## Section 2: Massing and Architecture

2201 N PERSHING DRIVE

**2201 N Pershing Dr  
History of Density/Massing Reductions**

1 NORTH ELEVATION - BLDG. #1 - FACING NORTH PROPERTY LINE

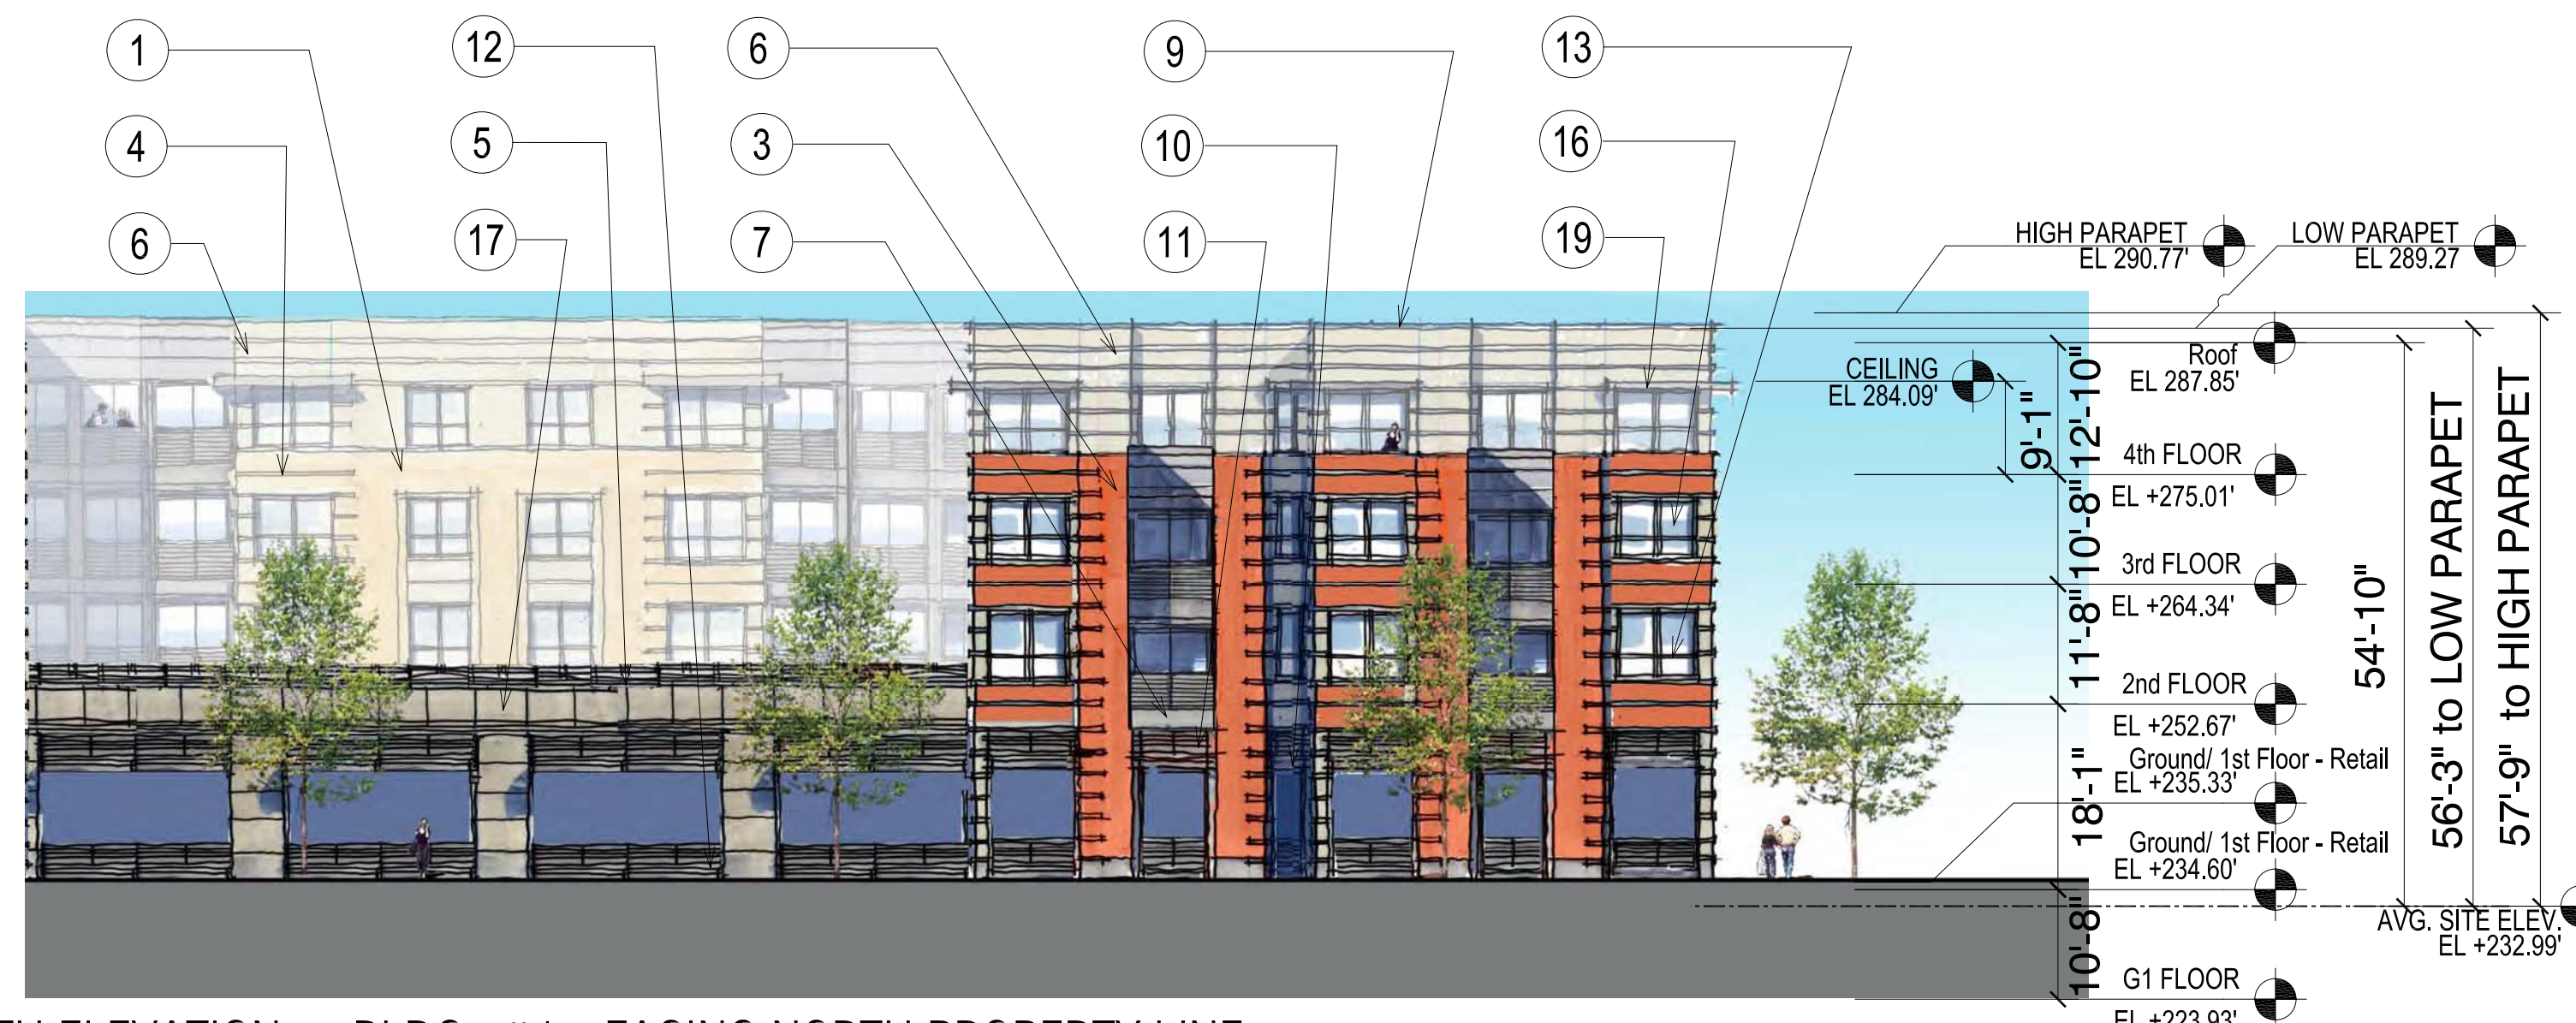
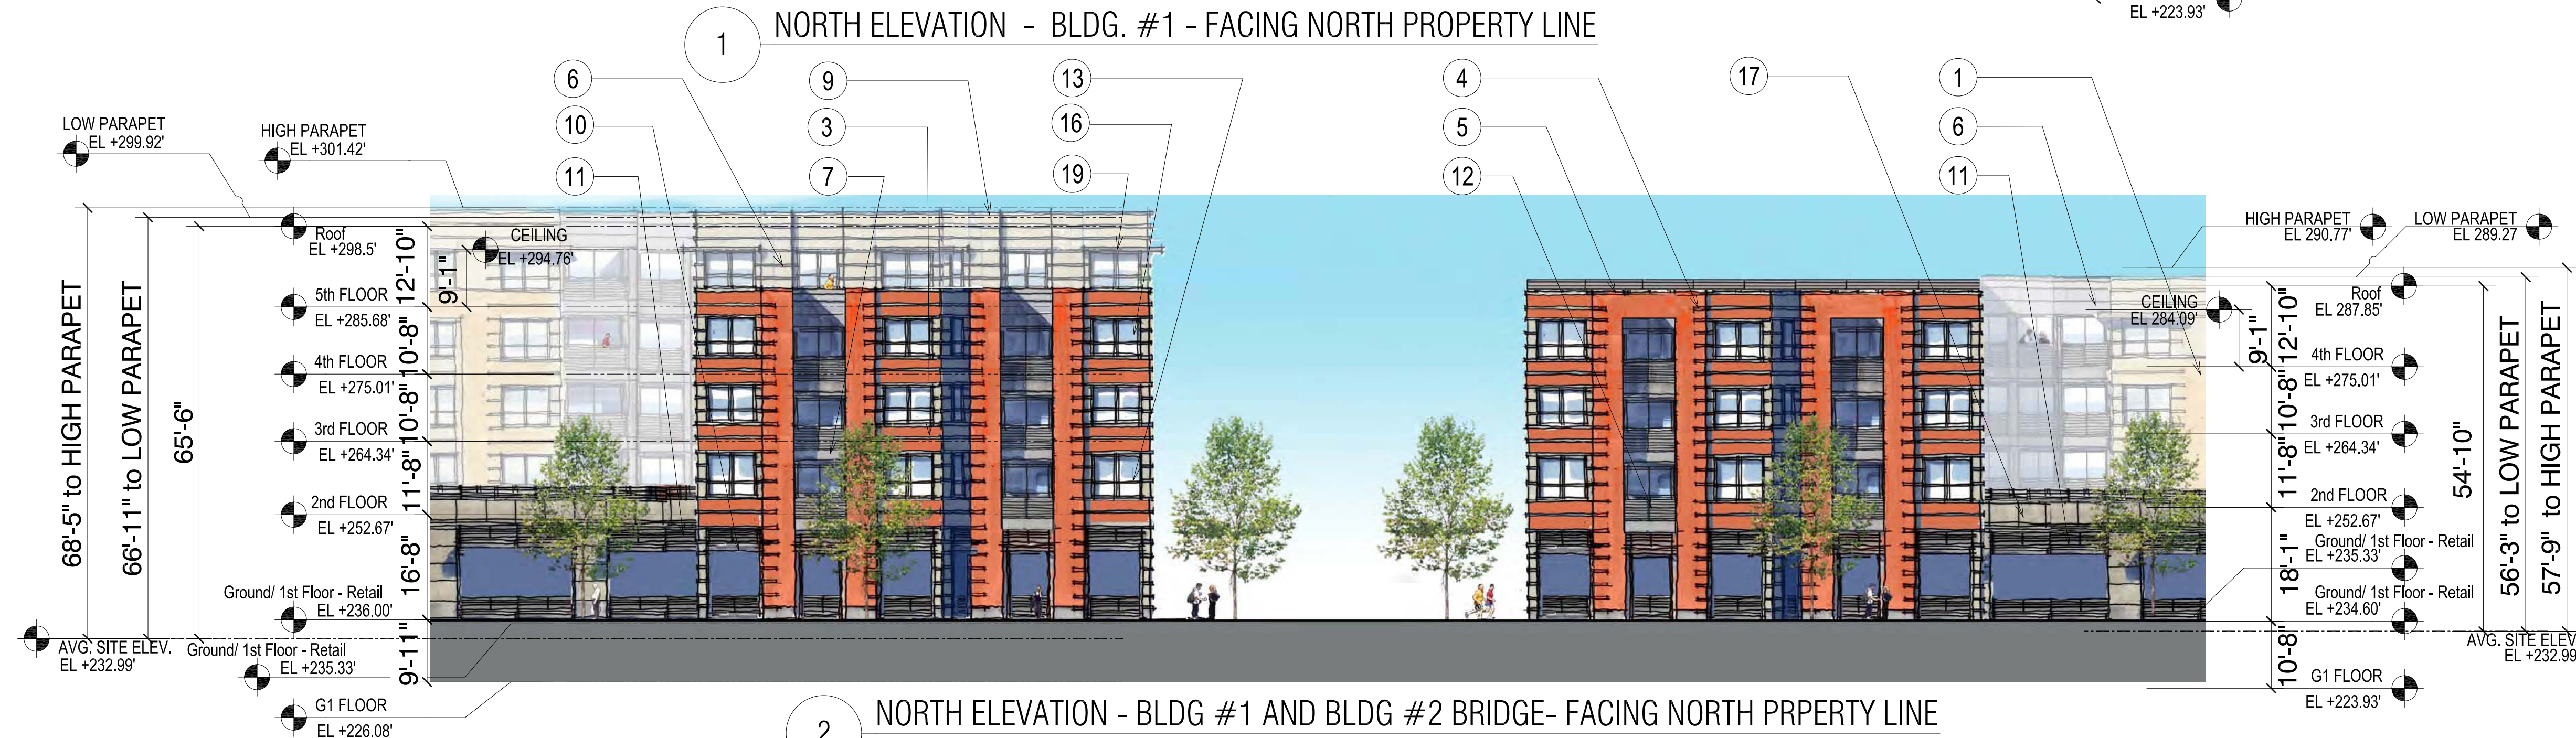
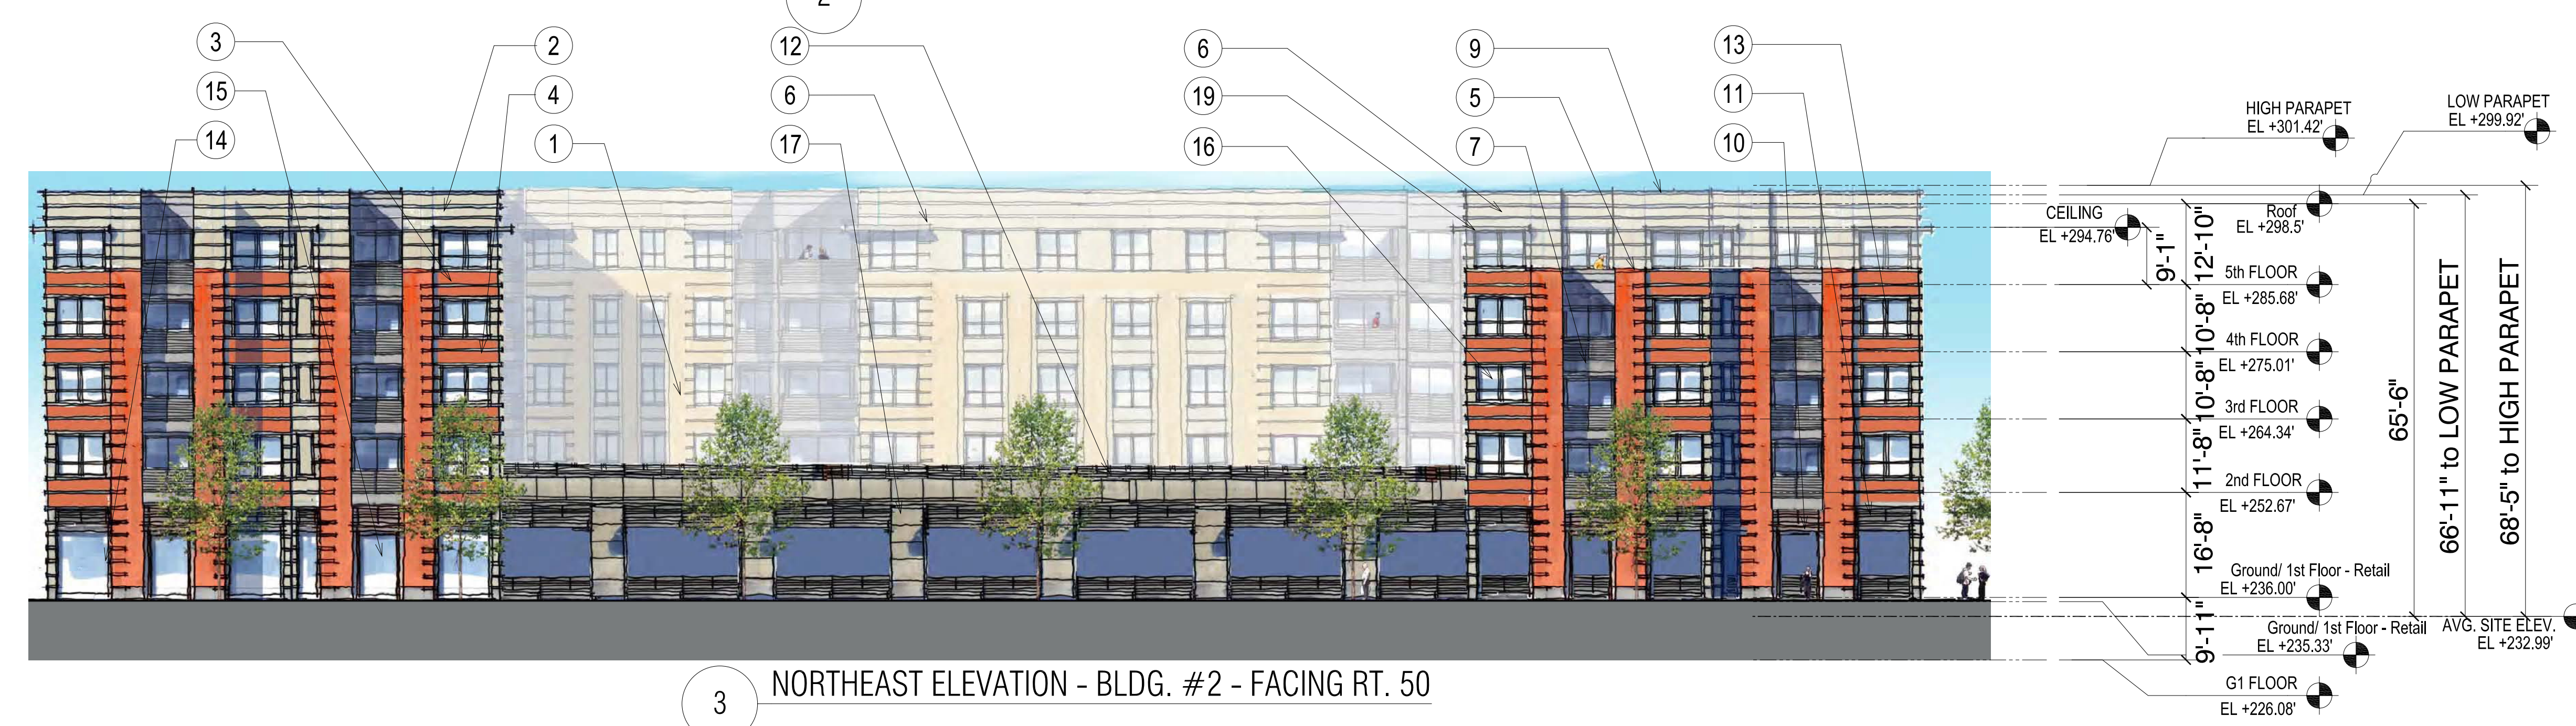
**Will Hardie panel be used on the rear (north) façades?** While the vast majority of the rear (north) façades will be brick, Hardie panel (or similar cementitious fiberboard product) is being proposed for certain recessed areas facing the elevated private courtyards. In general, this type of material offers many advantages over traditional wood products, including extended warranties (15 – 50 years); pre-finished colors which reduce the need for repainting, eliminate the release of VOC's during installation, and minimize maintenance requirements; and the incorporation of recycled content and local production to minimize environmental impact. There are many examples of architecturally compatible new single-family homes throughout Lyon Park and surrounding neighborhoods which feature cementitious siding material. While there are some older wrapped wood products which have exhibited some maintenance concerns over time, the newer cementitious products have an excellent track record for performance and low maintenance. In addition, the particular application proposed for this project does not require the same detailing (wrapping corners, angled seams) that has been found to be more challenging to properly execute in the field due to the architectural style planned here.

**How will the garage be screened along the north side of the project?** An architectural metal mesh screen will be installed under the second floor transfer slab that will project down from the slab above. There is also a half-wall at the ground level screening the parked vehicles and headlights. Between the top of the half-wall and the bottom of the metal screen below the transfer slab, decorative metal mullions will be installed. Sheffield Court also maintains a six-foot high masonry wall along the property line.
